Access Compliance Report

Public Rights-of-Way

(Pedestrian Signals)

Intersection ID: N/A	Main Street:	Cross Street: N/A	Location: N/A
ADA ID: 9564D78A8518	Signal Type: Two Push Buttons-APS	Overall Compliance: No	Severity Score: BTN 1:N/A BTN 2: N/A No BTN: N/A
Codes/Mitigation Info/Possible Solution		Field Measurements/Component Compliance

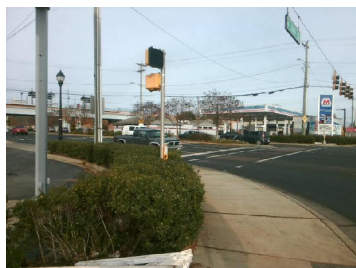
PROW/ADA: TMUTCD 4e.08, R404.2, R404.3, R404.7.3

Yes	B 1 Clear Xing Direction?	ClearlyMarked	Yes	B 2 Clear Xing Direction?	ClearlyMarked
	B 1 Crossing Direction	To E		B 2 Crossing Direction	To N
Yes	B 1 DistanceTo XWalk (in)	0.0	No	B 2 DistanceTo XWalk (in)	95.0
No	B 1 DistanceTo Curb (in)	141.0	No	B 2 DistanceTo Curb (in)	126.0
Yes	B 1 Diameter (in)	2.0	Yes	B 2 Diameter (in)	2.0

Possible Solutions: Replace Signal Push Button With APS Button on New Post. Remove & Relocate Sign.
